SERVICE LETTER 246

E-Dump System, Water Rudder Retract Cable Interference

Aircraft Makes/Model(s):	Float Model(s):	Compliance: Optional	By: MAS
Air Tractor AT-802 and AT-802A	10000A	Part Number: 1005051	Approved: SDW
		Date: 4/14/2022	Revision: B

Figure 1 – Example of Interference

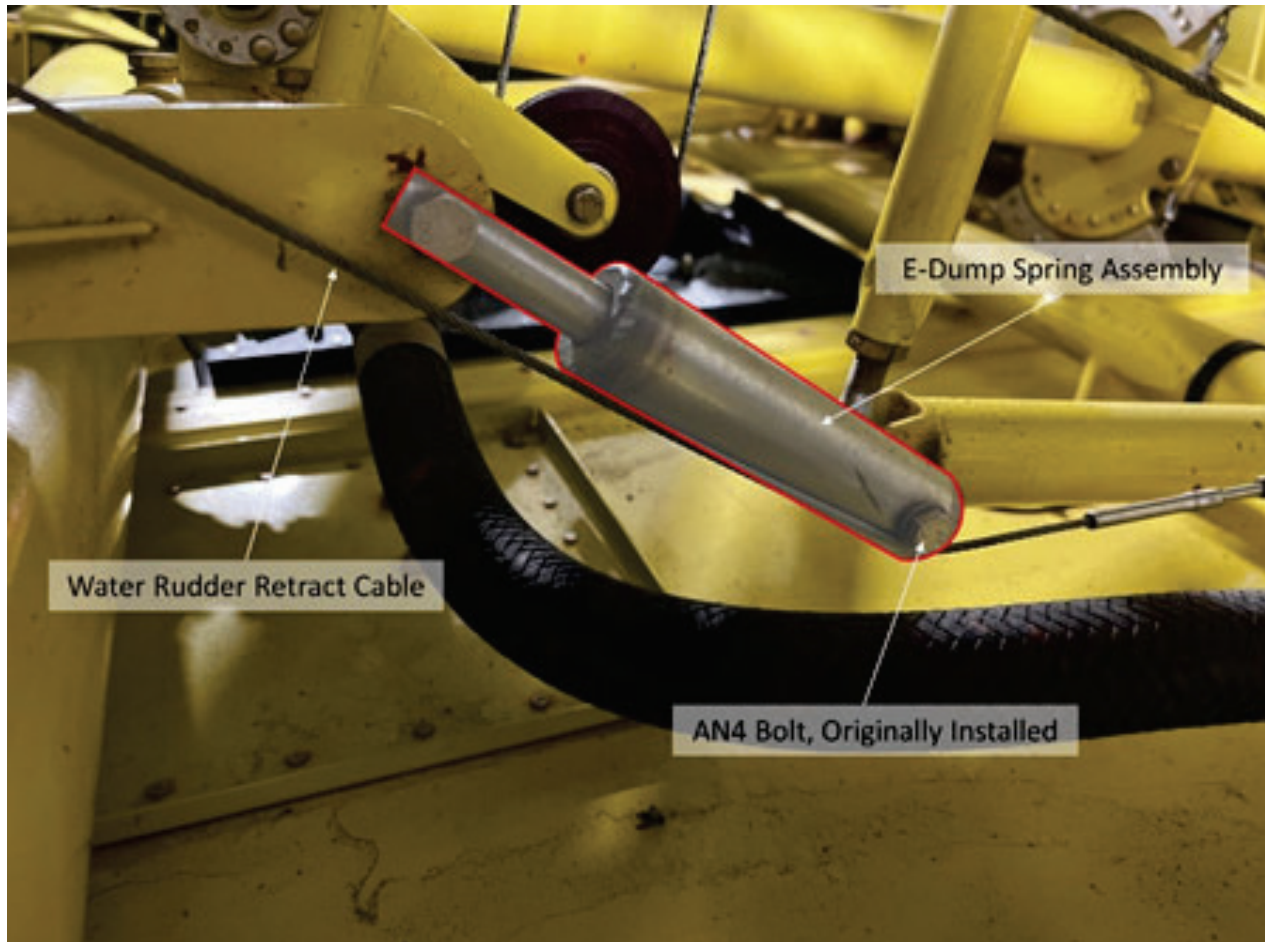
The water rudder retract cable may become caught on the Emergency Dump Spring Assembly (Air Tractor PN 71134-1), especially with the manual (non-electric) rudder retract system due to the water rudders being able to “bounce” while in the retracted position, creating momentary slack in the cable.

1. Position and prepare aircraft for safe maintenance.
2. Remove panel(s) as needed to gain access to area aft of hopper on L/H side.
3. Replace the originally installed AN4 bolt and MS21044N4 nut at the aft end of the E-Dump Spring Assembly (Air Tractor PN 71134-1) with AN24-36A clevis bolt and MS21083N4 nut and NAS1149F0463P washers as required. Do not overtighten, as doing so may restrict movement of the linkage. Refer to Figures 1 and 2. Cable pulleys and adjacent fuel line may be massaged slightly for additional clearance.
4. Actuate E-dump handle to test for interference and proper range of motion and make any necessary adjustments.
5. Reinstall aircraft panels.
